# UNITED STATES PATENT AND TRADEMARK OFFICE

| APPLICATION NO.  | FILING DATE | FIRST NAMED INVENTOR | ATTORNEY DOCKET NO.      | CONFIRMATION NO. |
|--|-------------|----------------------|--------------------------|------------------|
| 10/659,384   | 09/11/2003  | Geum-Jong Bae        | 239/169 DIV              | 3795             |

## Office Action Summary

## **DETAILED ACTION**

FIG. 3e

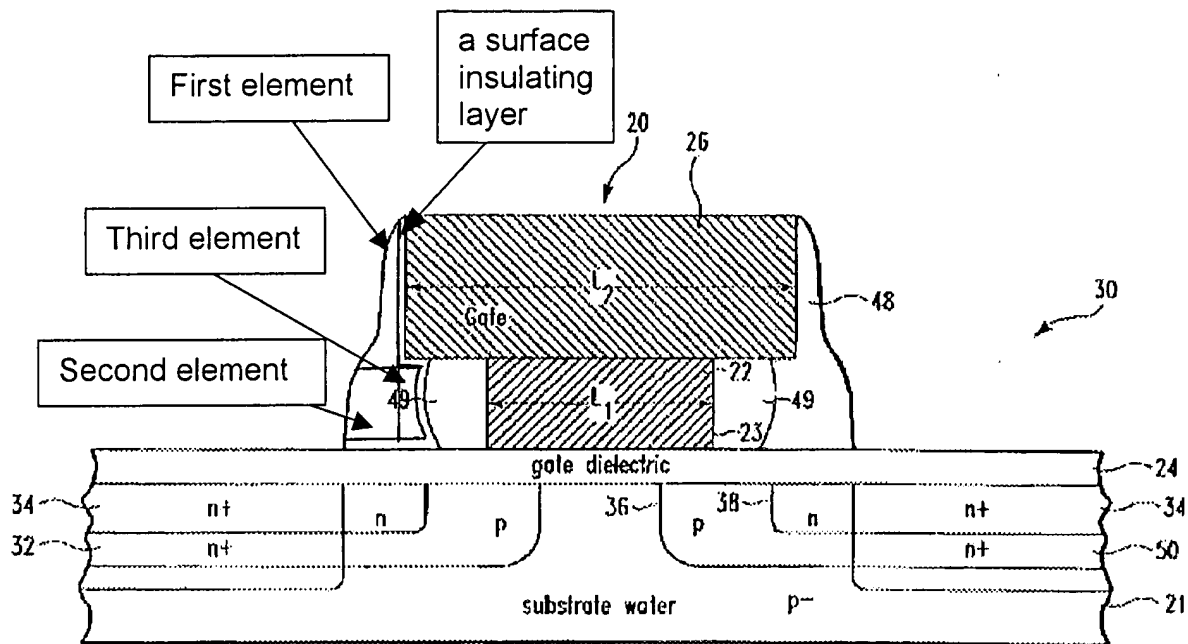
With respect to claims 20, Furukawa et al. discloses (fig. 3e, cols. 4-5) a semiconductor device comprising:

a T-shaped gate electrode (20) disposed on a semiconductor substrate (21), the T-shaped gate electrode (20) having a wide portion (26) and a narrow portion (22), the narrow portion disposed between the wide portion and the semiconductor substrate (21), so as to have an undercut region adjacent to the narrow portion;

an L-shaped lower spacer (48) covering a top surface of the semiconductor substrate at both sides of the T-shaped gate electrode (20) and covering sides of the wide portion of the T-shaped gate electrode (20), the L-shaped lower spacer (48) having a first element disposed substantially perpendicular to the semiconductor substrate (21), and having a second element disposed substantially parallel to the semiconductor substrate, the second element extending from the first element laterally away from the T-shaped gate electrode (20);

a low-concentration impurity region (34) formed in the semiconductor substrate at both sides of T-shaped gate electrode (20); and

a high-concentration impurity region (50) formed in the semiconductor substrate next to the L-shaped lower spacer (48).

Furukawa et al. fails to disclose a mid-concentration impurity region disposed between the high-and low-concentration impurity regions (50 and 34). However, Matsuda discloses that a mid-concentration impurity region (28) is disposed between the low-concentration impurity region (26) and high-concentration impurity region (34) (see fig. 3 and col. 9, lines 39-41). Therefore, it would have been obvious to one having ordinary skill in the art to modify the device of Furukawa et al. by having a mid-concentration impurity region disposed between the high- and low-concentration impurity regions as taught by Matsuda in order to provide the known purpose of lower electrical field thereby improving hot carrier performance.

With respect to claim 21, Furukawa et al. discloses that lower and upper conductive layer patterns (22 and 26) are sequentially stacked, wherein the upper conductive layer pattern (26) is wider than the lower conductive layer pattern (22) (see fig. 3e).

With respect to claim 22, Furukawa et al. discloses that the L-shaped lower spacer (48) further comprises a third element extending into the undercut region, the third element disposed substantially parallel to the semiconductor substrate and extending from the first element laterally towards the T-shaped gate electrode (fig. 3e).

With respect to claim 26, Furukawa et al. discloses that a surface insulating layer (48) intervened between the gate electrode (20) and the lower spacer (48) (see fig. 3e). **\*\*Notice:** as interpreting the claim in a broad scope, a surface insulating layer can also be the same as the lower spacer because the claims do not distinct the material of the lower spacer and the surface insulating layer. Therefore, the lower spacer and the surface insulating layer are considered as one layer.

With respect to claim 27, Furukawa et al. discloses that the first element of the L-shaped lower spacer (48) completely covers sides of the wide portion (26) of the T-shaped gate electrode (20) (see fig. 3e).

With respect to claim 28, Furukawa et al. discloses that the second element of the L-shaped lower spacer (48) partially covers the narrow portion (22) of the T-shaped gate electrode (20) (see fig. 3e).
